Technical Service Bulletin

| Technical Service Bulletin: TSB130055 | Released Date: 13-May-2013 |
| Heavy Duty Thermostat Stuck Open and/or Missing Flange Seal | |

Figure 1: Old Thermostat, Part Number 4318197 vs New Thermostat, Part Number 4318947

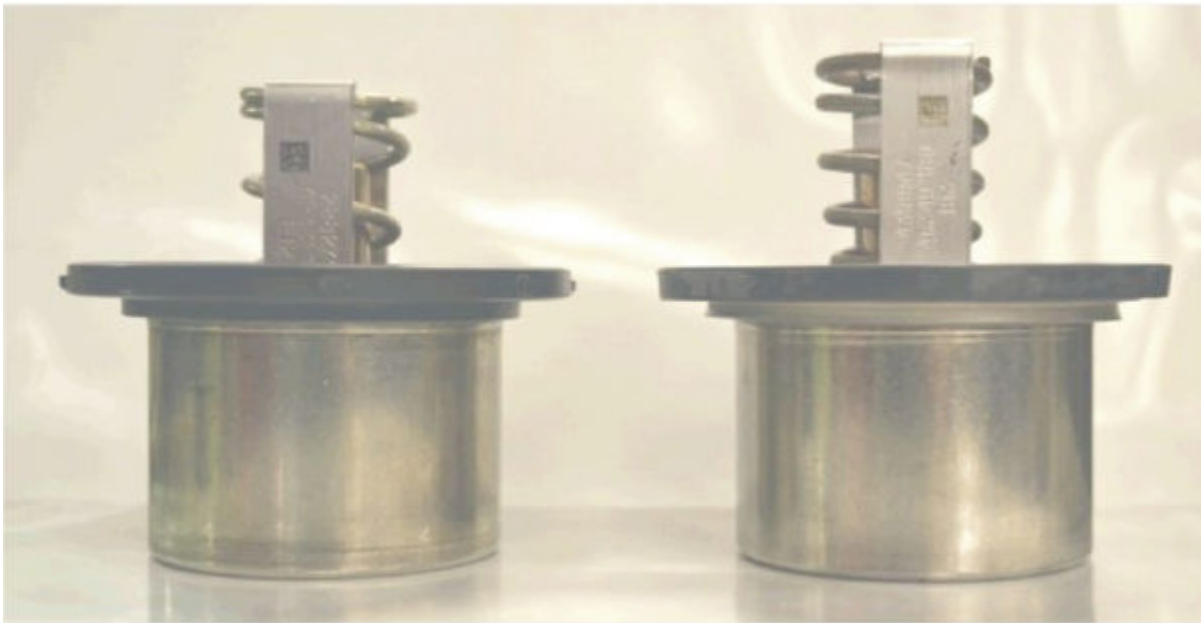
Heavy Duty (HD) engines have been experiencing excessive cooling of the engine coolant as a result of thermostat failures. This document addresses two failure modes for HD thermostats: thermostat stuck/seized in the open position and thermostat flange seal failures. During operation, fluid forces were greater than the return force of the spring, preventing the thermostat from closing fully and leading to a stuck open/seized thermostat. Also, during operation, the elastomer covering the thermostat flange fails, causing the elastomer seal to chunk out and in some cases a loss of the elastomer seal. Both failures lead to excessive cooling by allowing for continuous coolant flow to the radiator.

A new thermostat has been released to address both the stuck open and the flange seal failure modes that were reported. The new Cummins Part Number is 4318947, with the engine serial number (ESN) firsts from the plant in Table 1: ESN Firsts below. This new thermostat design has a higher force return spring which resulted in taller spring retaining arms. The flange seal of the thermostat has reverted back to a previous design using a 3-piece construction. This 3-piece flange consists of a metal flange, elastomeric seal, and steel retaining ring. Refer to Figure 1: Old Thermostat, Part Number 4318197 vs New Thermostat, Part Number 4318947, below for comparison of old and new thermostat.

Note : This new thermostat, Part Number 4318947, is **not** compatible with engines

assembled with dual thermostat housing options. The result of longer spring and spring retaining arms results in contact with the dual thermostat housing, preventing the thermostat from functioning properly. For engines using dual thermostat housing, use Part Number 4336659 for repairs.
